Subject: MHI's Third Responses to US-APWR DCD RAI No.197-1800 Revision 0

Third Responses to Request for Additional Information
No. 197-1800 Revision 0

RAI NO.: NO. 197-1800 REVISION 0
SRP SECTION: 19 – Probabilistic Risk Assessment and Severe Accident Evaluation
APPLICATION SECTION: 19
DATE OF RAI ISSUE: 2/9/2009

QUESTION NO.: 19-303

Figure 1 Methodology for Calculating Probability of TISGTR

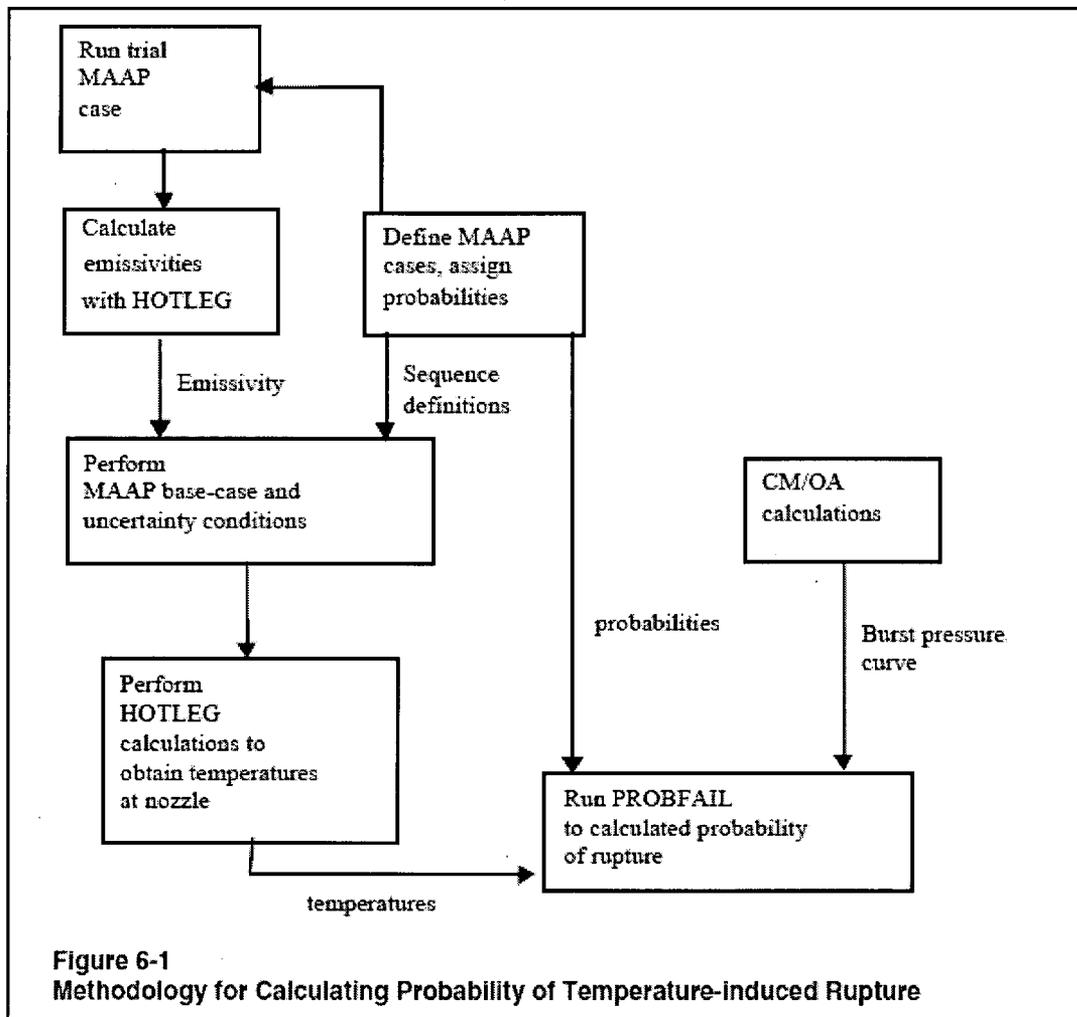
Please explain the methodology and results of the evaluation of induced steam generator tube ruptures, given failure to depressurize. Also, provide the discussion of the results of scenarios where the steam generators are also depressurized. In addition, please justify the assumption of zero break areas for hot leg creep rupture and temperature-induced steam generator tube rupture.

A flowchart of the methodology for calculating the probability of rupture in U-tube plants is shown in Figure 1, which is Figure 6-1 extracted from the report.
